## PLANNING DIVISION STAFF REPORT

**Project Address:** 2121 North Stoughton Road (District 17 - Ald. Baldeh)  
**Application Type:** Conditional Use  
**Legistar File ID #** [38018](#)  
**Prepared By:** Kevin Firchow, AICP, Planning Division  
Report includes comments from other City agencies, as noted.

**Requested Action:** Approval of a conditional use to allow limited production and processing and outdoor storage in an existing commercial building in CC (Commercial Center) Zoning.

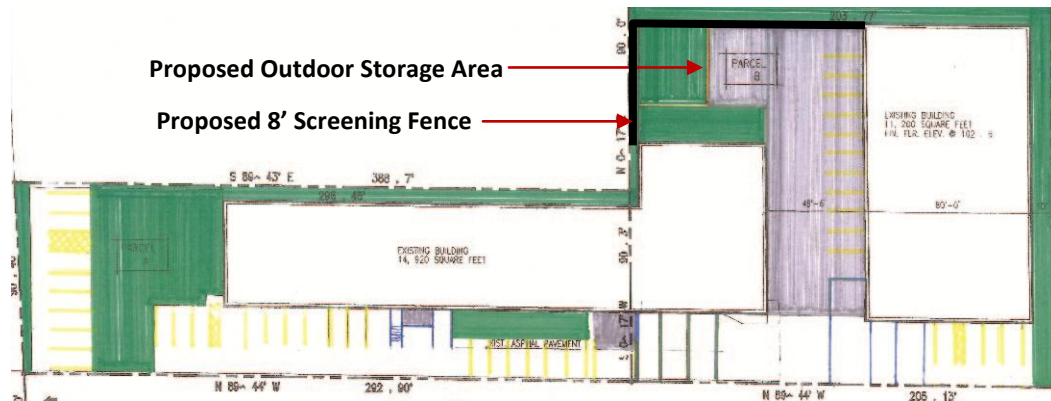
The second conditional use request is to establish a small, fenced storage area between the two subject buildings. An excerpt from the submitted site plan is below:

The letter of intent states that the storage area will be enclosed with an eight foot tall fence. The adjacent loading zoning will be reconfigured and converted from gravel to concrete. Such details should be clearly defined in the plans submitted for final sign-off.

1. That the site plan submitted for final sign-off clearly labels the location of the screening fence and pavement type (including areas of gravel or concrete). Other improvements described in the letter of intent including the retaining wall and loading zones should also be clearly depicted and drawn to scale for final review by City Agencies.
